| Fi            | le                                 | 1991-0020 Name: <u>St. Mary's Ho</u>   | spita    | al - | Rezone & Parking Lot                                   |  |  |  |  |  |

# REVIEW SHEET SUMMARY

TITLE HEADING: Rezone & Parking Lot

ACTIVITY: Rezone from RSF-8 to PB & Final Plan for a Parking Lot for

# PARKING LOT PROJECT 8/01/92

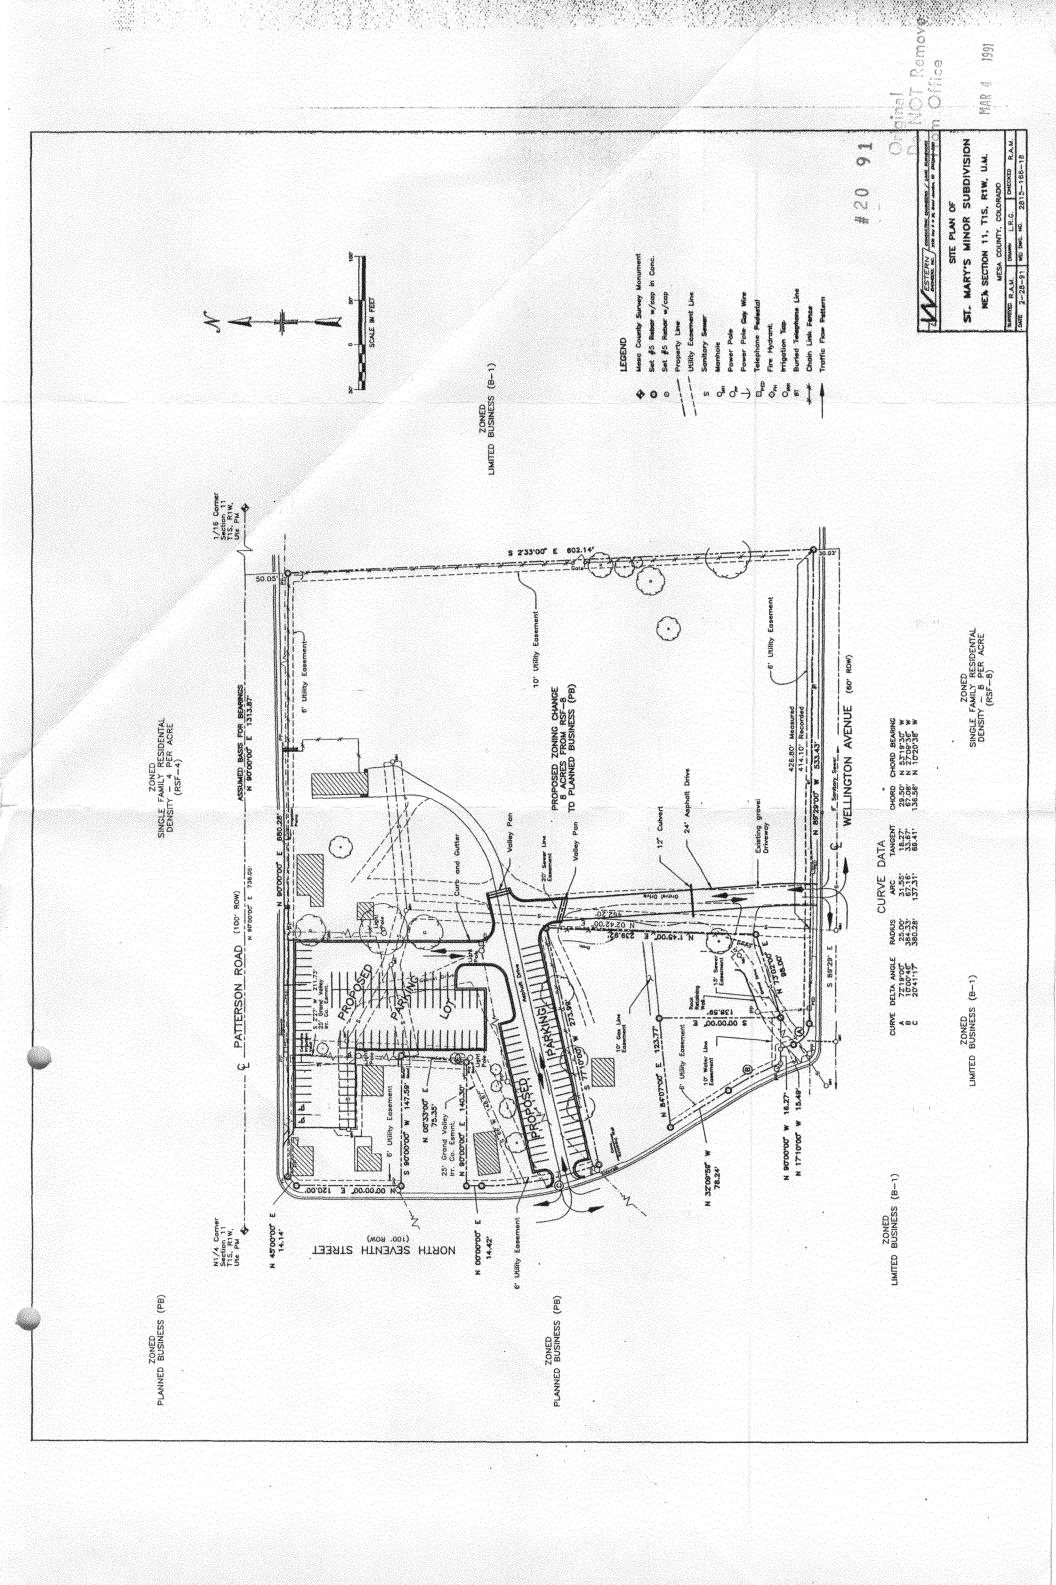
At the July 7th Planning Commission Meeting this agenda item was tabled until the August meeting with a request from the Planning Commision for representatives from St. Mary's and City Staff to review the issues of potential pedestrian and vechicular traffic problems. Subsequent to the July 7th meeting, 4 meetings between St. Mary's Staff and City Staff have occurred, both in the City Offices and on-site at St. Mary's. As a result of these meetings, the following Plan Of Action has been developed to prepare this agenda item for approval at the August meeting of the Planning Commission:

| LOCATION        | ACTION(Numbers refer to attached drawing)   |
|-----------------|---|
| 7TH & PATTERSON | <ol> <li>Improve line-of-sight at intersection by taking 10 existing parking spaces out of service</li> <li>Move Stop-Bar back for Left Turn and Thru Lane</li> <li>Lengthen walk signal across 7TH</li> <li>Add new sign - "No Right Turn on Red When Pedestrians in Crosswalk"</li> </ol> |
| 7TH STREET      | 5. Add fencing  |
| WELLINGTON      | 6. Add signage(Public and Private) directing cars east on Wellington  |
|                 | 8. Remove old curb cuts on Patterson  |

This Plan Of Action was developed after extensive studying of existing and projected pedestrian and vechicular traffic patterns in the areas adjacent to the new parking lot. It was determined that no additional action should be required either at 7Th and Wellington or on 7TH between Patterson and Wellington. St. Mary's will carry-out an extensive Employee Education Program regarding desired pedistrian and vechicular patterns for the new lot.
